REGULAR MEETING OF THE BIRMINGHAM PLANNING BOARD

WEDNESDAY MARCH 26, 2025 – 7:30 PM

SUBJECT: 280 E. Lincoln – Grace Baptist Church – Special Land Use Permit, Final Site Plan and Design Review

LANDSCAPE PLAN

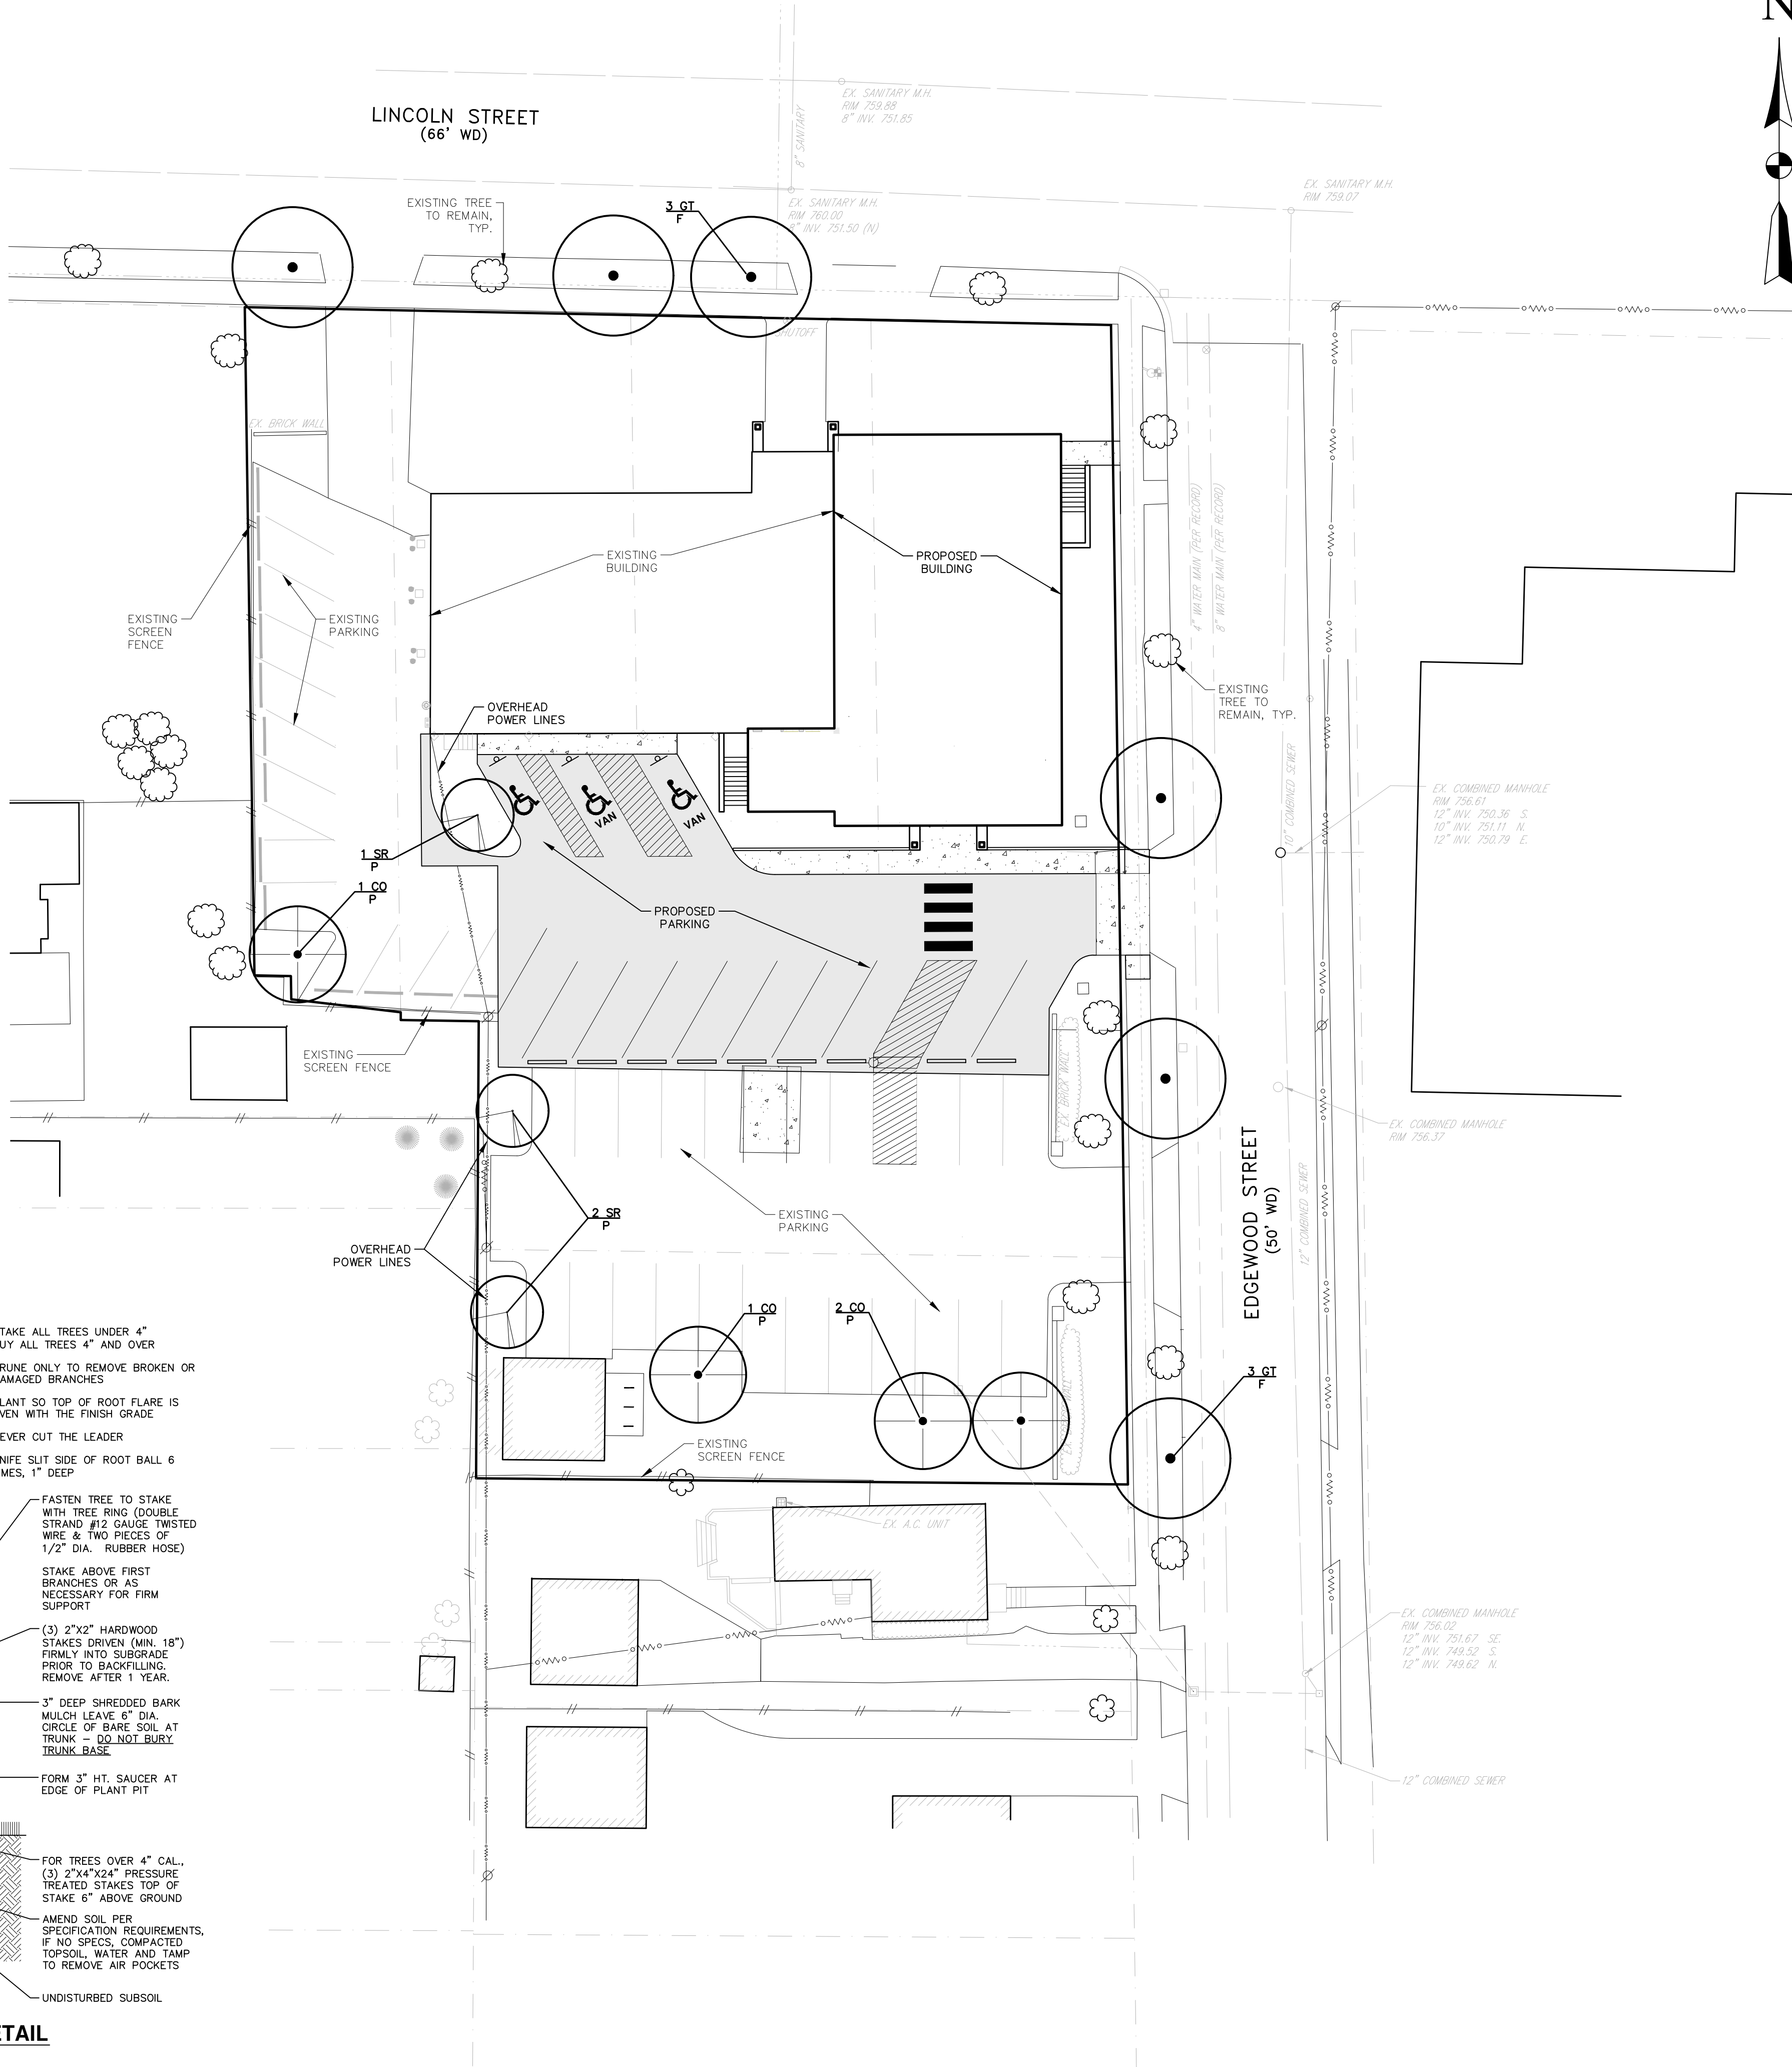
- 3.4 Landscaping – There are changes proposed to the landscaping on site as a part of the Special Land Use Permit, Final Site Plan and Design Review application submitted. None of the proposed plants appear to be on the prohibited species list. Article 4.20 (F) of the Zoning Ordinance requires parking lots greater than 7,500 sq. ft. to include interior landscaping areas that total not less than 5% of the total parking lot interior area. Each interior planting area is required to be at least 150 sq. ft. and not less than 8 ft. in any dimension. One canopy tree is required for each 150 sq. ft. and the interior planting areas shall be located in a manner that breaks up the expanse of paving throughout the parking lot interior. Per Article 4.20 LA-01 of the Zoning Ordinance, the Landscape Standards section does not apply to the R2 Zoning District. The submitted site plans include a landscape plan with 6 interior landscaping areas that comprise over 5% of the total parking lot area. There are 7 trees proposed within interior landscaping areas – 4 Hackberry and 3 Japanese Tree lilacs. **The Planning Board may wish to recommend that the site plan be required to meet some or all of the Parking Lot Landscaping Standards outlined in Article 4.20 (F) as a condition of approval of the SLUP amendment.**

- 3.5 Streetscape – There are street trees proposed to the streetscape as a part of the Special Land Use Permit, Final Site Plan and Design Review application submitted. See attached memo from the DPS forestry staff. The applicant will be required to comply with all requests of city departments. Street trees are not required in the R2 Zone. However, the applicant has included street trees in the site plan. **The Planning Board may wish to recommend the site plan be required to meet the Street Trees standards outline in Article 4.20 (G) of the Zoning Ordinance and as directed by DPS staff as a condition of approval of the SLUP amendment.**

- City tree #4624, a 6" DBH American Elm 'Princeton' tree needs to be identified, protected and preserved throughout construction, bringing total existing City trees to 6.
- Hardscape, accessible ramps, and line-of-sight concerns for exiting vehicles and pedestrians exist on E. Lincoln. DPS recommends all plantings to occur on Edgewood to satisfy street tree requirements.

- A tree permit will be required for planting (5) City trees on Edgewood. 2x 3-3.5" DBH Sweetgum 'Slender Silhouette' to be placed in easement adjacent to proposed addition. 3x 3-3.5" DBH Kentucky Coffeetree 'Morton' or 'Skinny Latte' in easements adjacent to parking lots. Exact locations attached for reference. Trees, species and distances should be shown on revised site plan and planted following the majority of construction activities.

3. The site plan is required to meet some or all of the Parking Lot Landscaping Standards outlined in Article 4.20 (F).
4. The site plan is required to meet the Street Trees standards outline in Article 4.20 (G) of the Zoning Ordinance and as directed by DPS staff;

PROPOSED LOWER LEVEL FLOOR PLAN

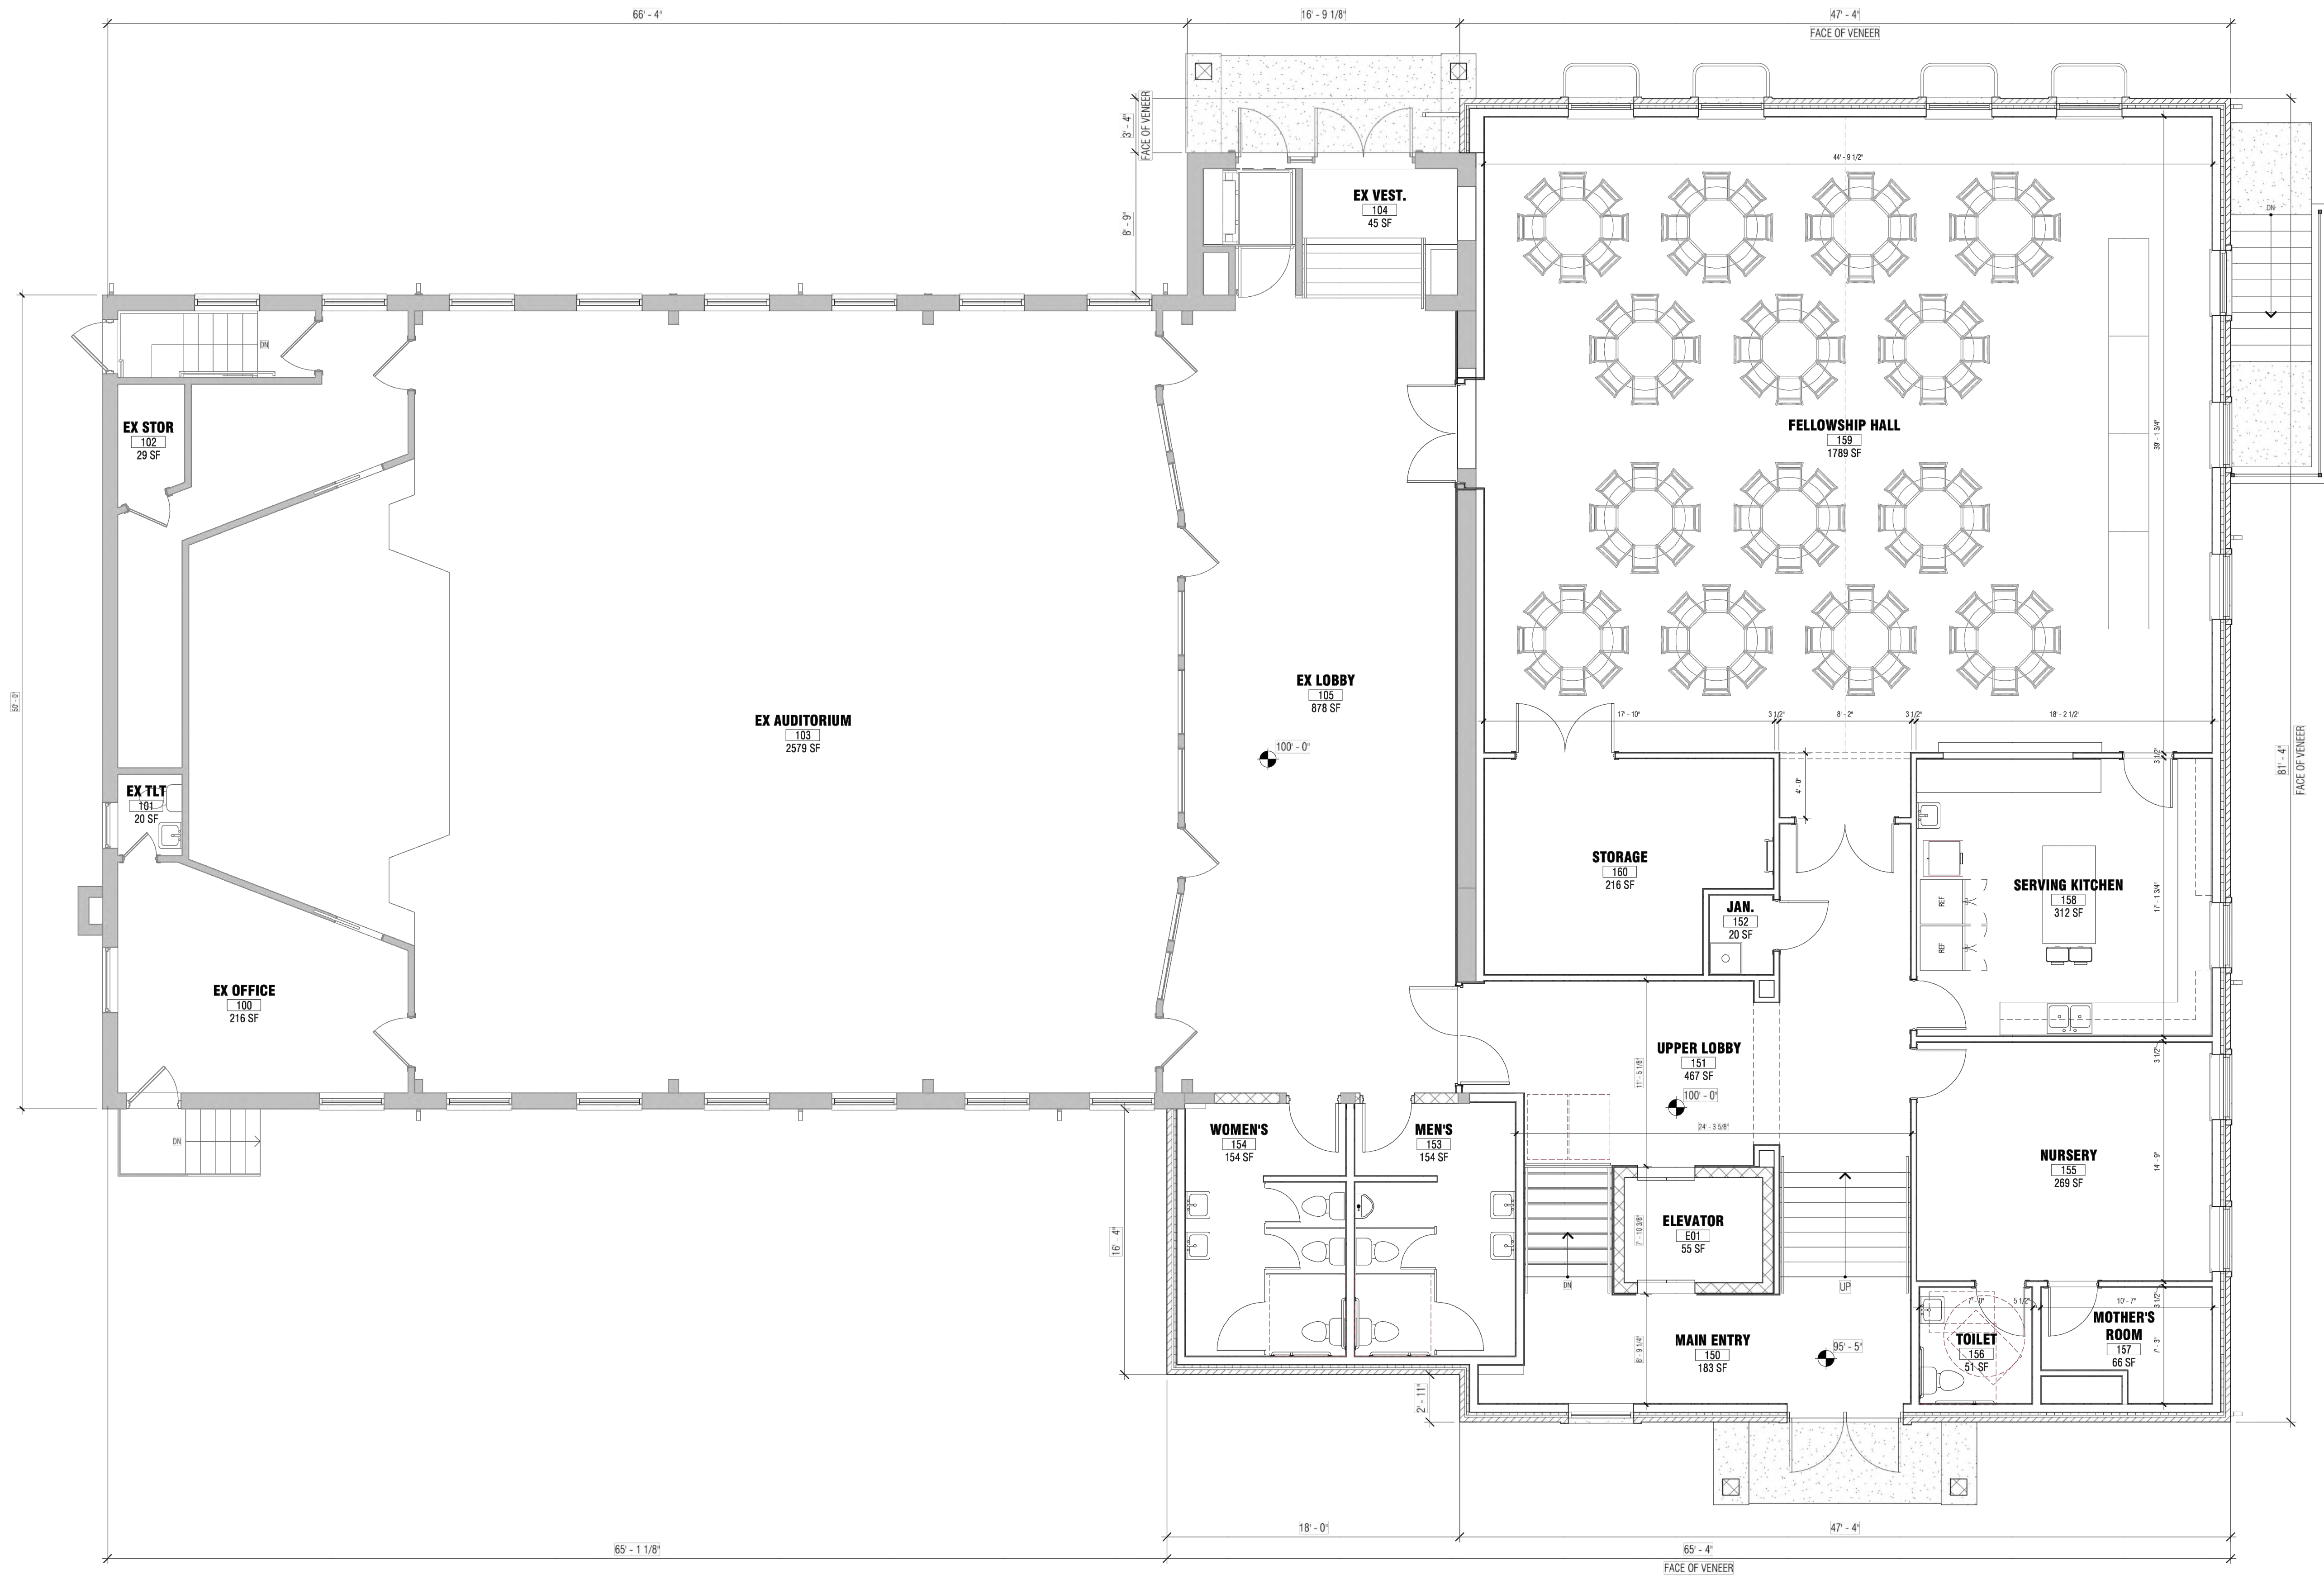
1. Provide detail egress route of the existing lower level classrooms.
2. Appears that a fire suppression system will be required.
3. Exterior exit stairway needs to be protected in accordance with the outdoor conditions per section 1011.7.2
4. Exterior exit stairway shall have the minimum fire separation distance from the property line along Edgewood per section 1027.5
